SUNDRY NOTICES AND REPORTS ON WELLS
Do not use this form for proposals to drill or to re-enter an abandoned well. Use form 3160-3 (APD) for such proposals.

8. Well Name and No.
BENGAL C 3

Re: Permanent Abandonment
Well: Bengal C3

CONDITIONS OF APPROVAL

Planned P & A Schematic

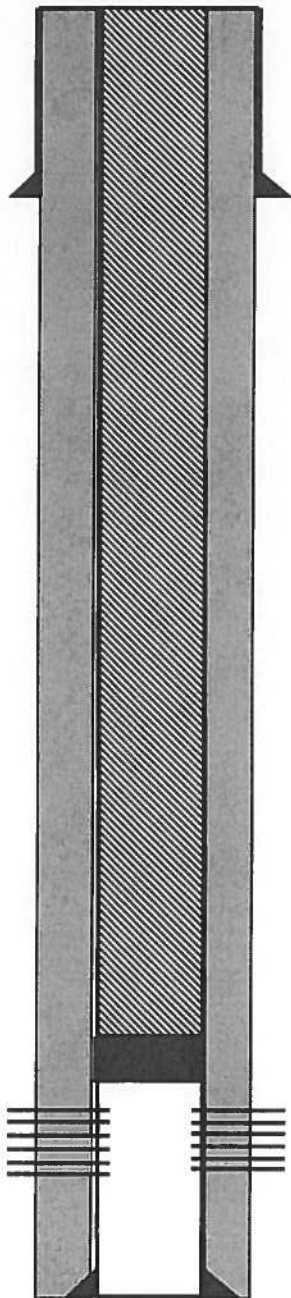
- The proposed plugging plan, if executed as presented, will adequately protect the freshwater sands in this well bore.

- Please ensure that the tops of the Pictured Cliffs and Fruitland formations as well as the entire Ojo Alamo aquifer, identified in this report, are isolated by proper placement of cement plugs. This will protect the freshwater sands in this well bore.
